From: Lance Blaine [lance@red-cap.co.za]
Sent: 02 October 2012 11:22
To: Rebecca Thomas
Cc: Nicolene Venter_External
Subject: Re: Proposed Thyspunt Transmission Lines Integration Project: Revised DEIR available for public comment

From: Veronique Evans [mailto:VeroniqueE@sivest.co.za]
Sent: 21 September 2012 09:11 AM
Cc: Faith Kalibbala; Rebecca Thomas; Nicolene Venter_External
Subject: Proposed Thyspunt Transmission Lines Integration Project: Revised DEIR available for public comment

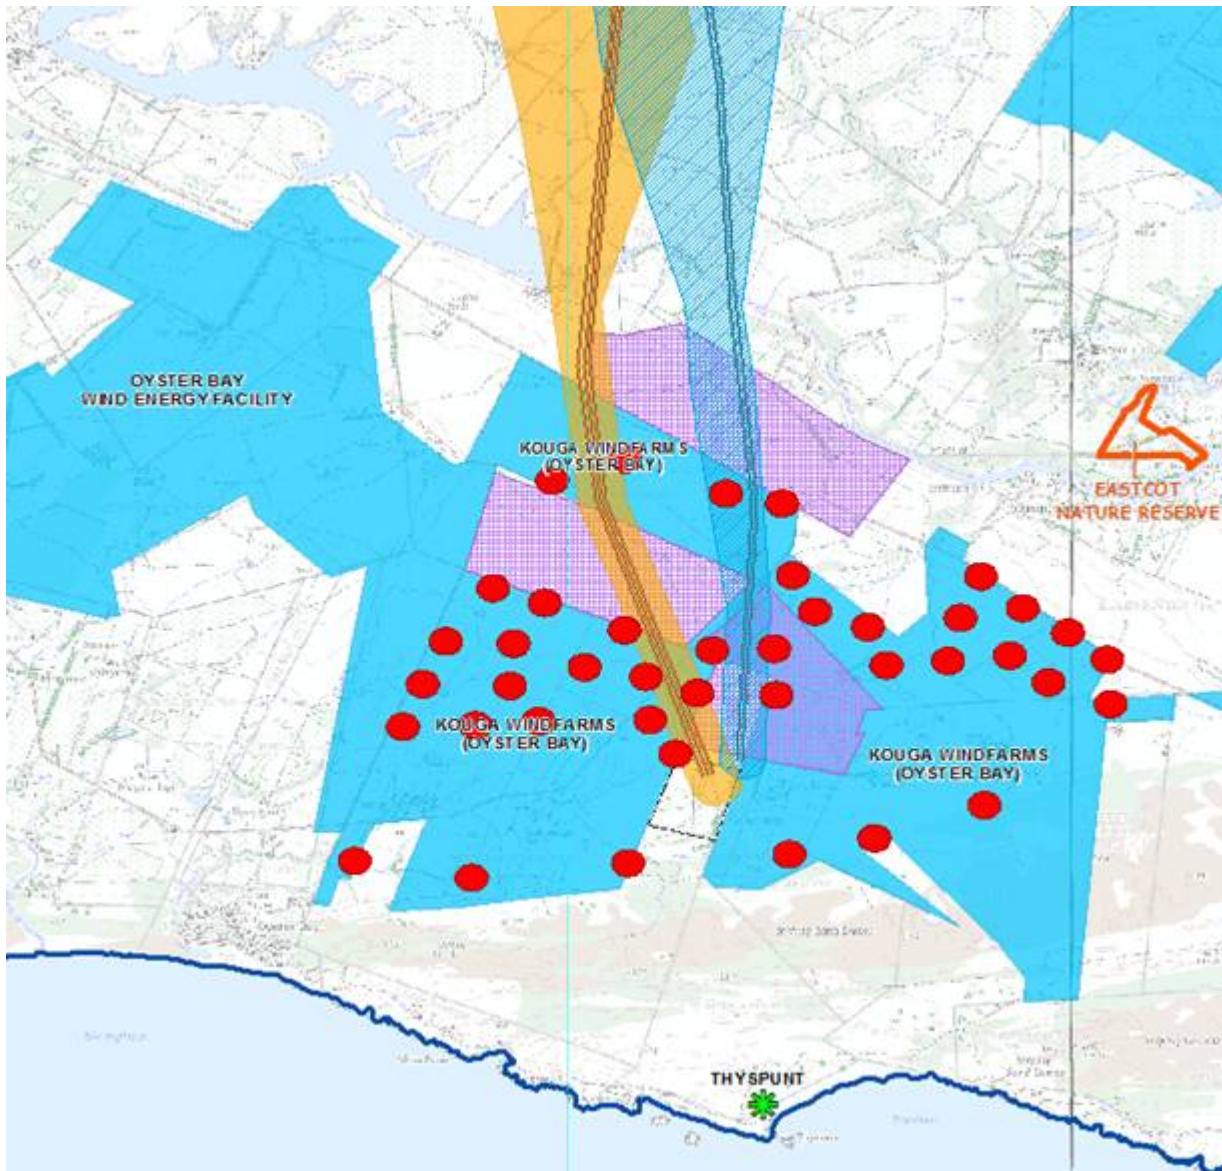
Thanks for this. At this high level it looks fine but would you be able to send me KML files for Google with the alignments and corridors for this area as that is the best way for me to be able to check?

Our agreement with Eskom is that their lines would be no closer than 202.5m from our turbines and 52.5m from our substation. The 202.5m was at their request they felt they needed to reduce this to 170m I don't foresee it being a problem.

Please also see the snapshot below which shows the turbine positions with a 170m buffer (as provided by RedCap) in relation to the new alignments. I hope this helps.

Please advise if this addresses your question/concern. From what I can tell the new alignments have been routed to avoid the turbines (including the buffer).
